ESIA Review

Independent 3rd Party Assessment of the Impacts on Water Resources and Geology, Biodiversity and Air Quality

Amulsar Gold Mine The Republic of Armenia

Investigative Committee of the Republic of Armenia

Figure 2.1.2: Flow Chart - Water management during closure phase (Figure 6.10.3 of the ESIA)

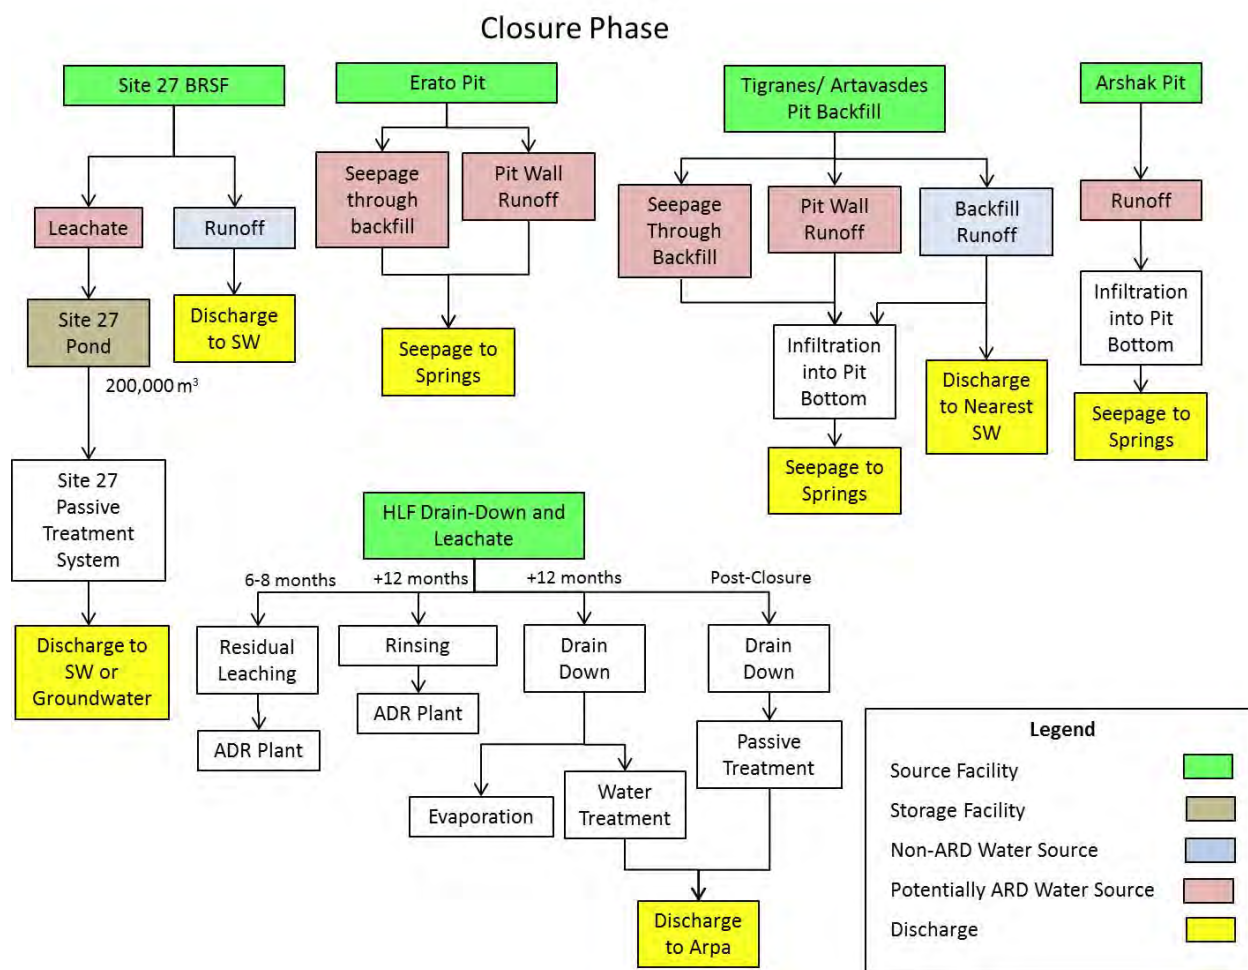
A flow chart of the water management during the closure phase presented as Figure 6.10.3 in Chapter 6.10 of the ESIA is shown below as Figure 2.1.2. The water from the residual leaching and rinsing are shown going to the ADR plant, and then inexplicably disappearing. GRE (2014d; page 71) gives an estimate of 2 million m³ of water in the HLF after rinsing. The water by this time has been in circulation for ten years and will have elevated levels of sodium, chloride, sulfate, nitrate and probably other ions as well. Assuming the volume of HL solution is in the same range as that remaining in the HLF after rinsing (*i.e.*, >1,000,000 m³), the management and disposition of such large volume of contaminated water should be addressed.

The ESIA proposes a dedicated PTS to be designed and implemented upon closure based on post-closure water quality monitoring and present generalized descriptions of processes for treating the leachate from the HLF post closure. This may be a reasonable approach; however, the ESIA should include plans for laboratory treatability and pilot testing to evaluate and confirm the feasibility and effectiveness of the PTS in treating the HLS and leachate and in achieving the discharge criteria. Furthermore, there are no contingency plans in case of the PTS failure to effectively treat the HLF wastewater or in future cases of PTS failure or emergency.

Figure 4.10.6: Small boulder with 50 plants of *P. porphyrantha*

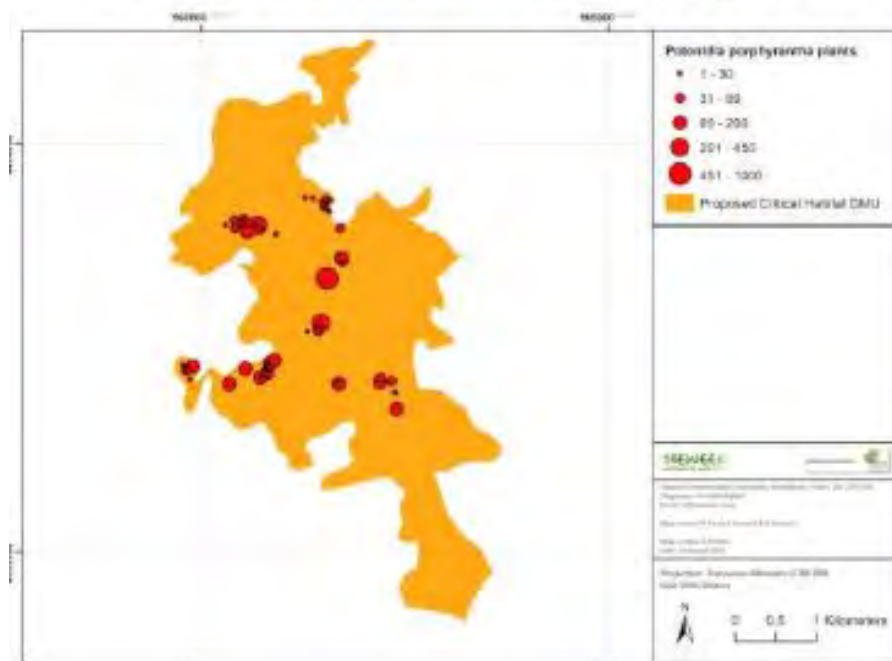
The distribution map of *Potentilla porphyrantha* (sampled points) is provided without description or mapping of the critical habitats for this species identified as “subalpine meadow with alpine elements” (in green in the below map) in which the species occurs on suitable rock substrate (see photo).

As per the map, the habitat will be heavily impacted by the project. The report states
